TO: Dr. Jesse Bacon, Superintendent
FROM: Danny Clemens, Director of Facilities
Date: September 24, 2024
RE: Bernheim - Change Order 27- Miscellaneous Unforeseen and Found Conditions **DC**

Change Order

PROJECT: *(Name and address)*
 Bernheim Middle School Renovation
 700 Audubon Drive, Shepherdsville, KY
 40165

CHANGE ORDER INFORMATION:
 Change Order Number: 027
 Date: September 30, 2024

ROOF DETAIL - MODIFIED WALL CONDITION @ GUTTER

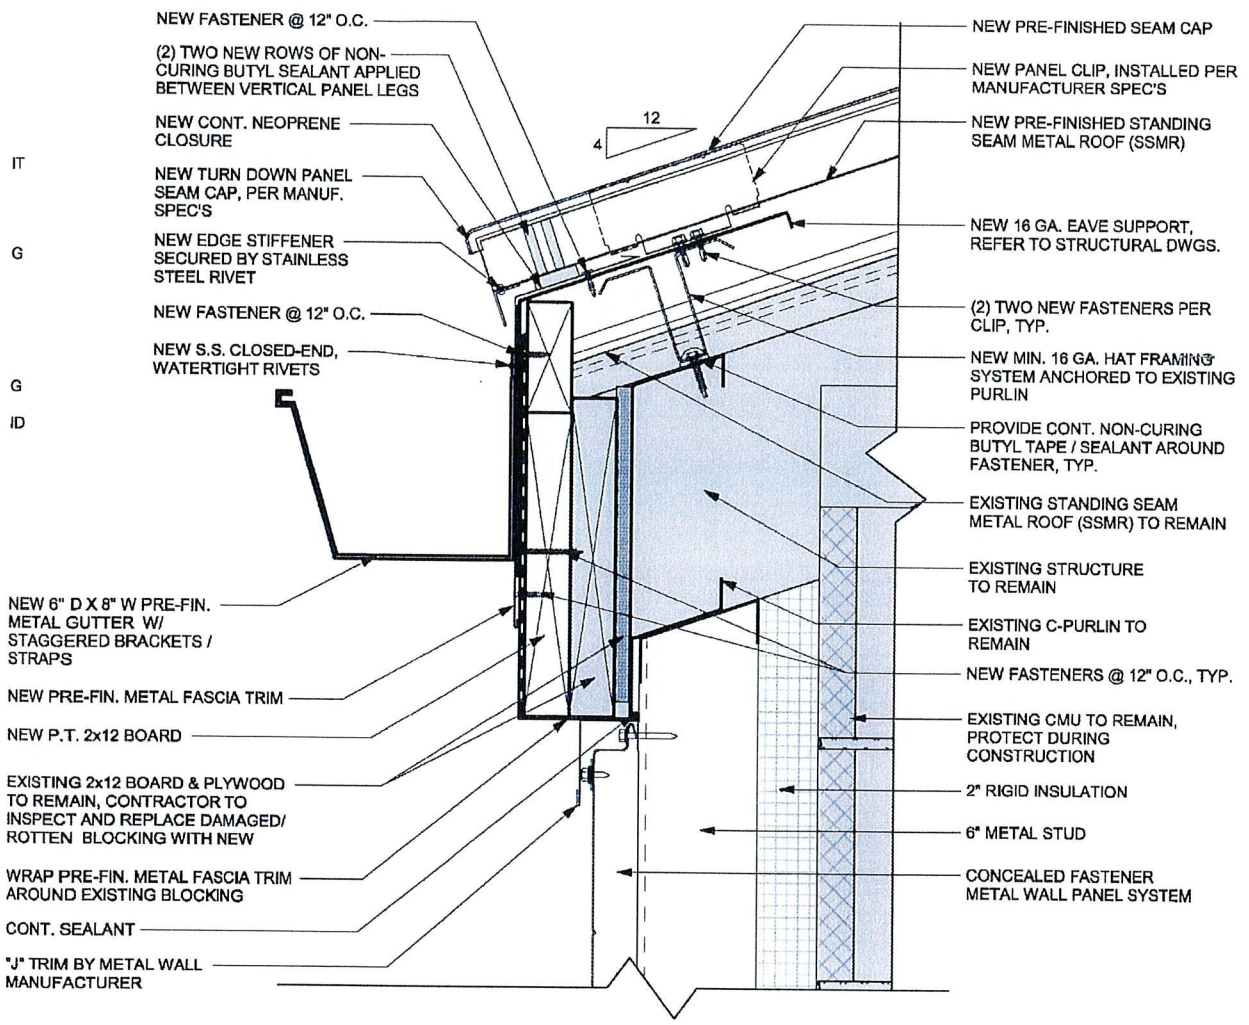
Item : 1 Fascia Board for gutter

Item : 1 Additional fascia board need not in plans

COR-39 Added Fascia Board at Gutters - \$17,366.00 – When the existing standing seam roof and metal fascia were removed, it was determined additional wood fascia boards were required to build out the fascia per design intent. Garland, the roof warranty holder, documented additional wood nailers in their onsite observations and field reports.

Photos/Pick Tickets

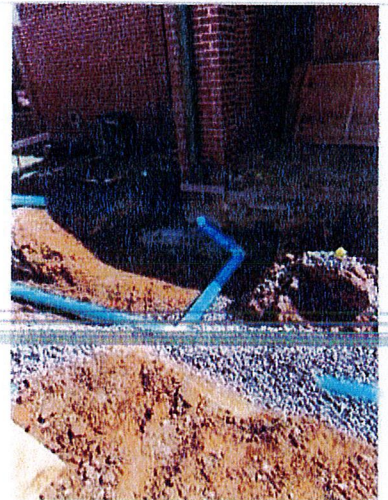
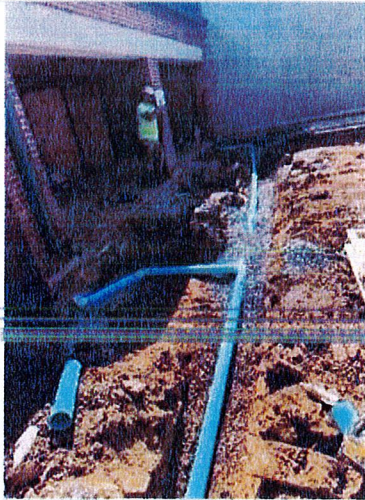
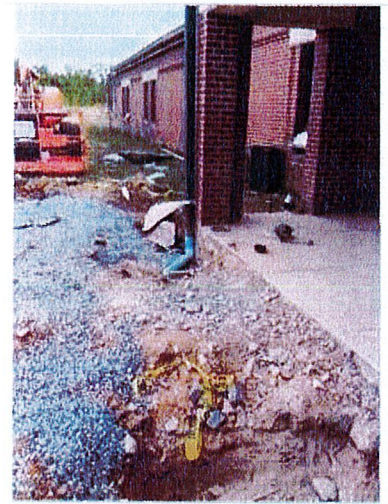
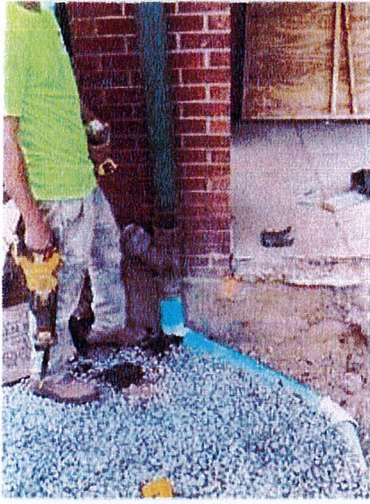
COR-41 - Canopy Drain - \$2,170.00 – The existing storm lines at the main entrance and cafeteria area were in disrepair when the area was excavated for the new canopy. Lines were replaced due to condition.

Task New 4" roof drains
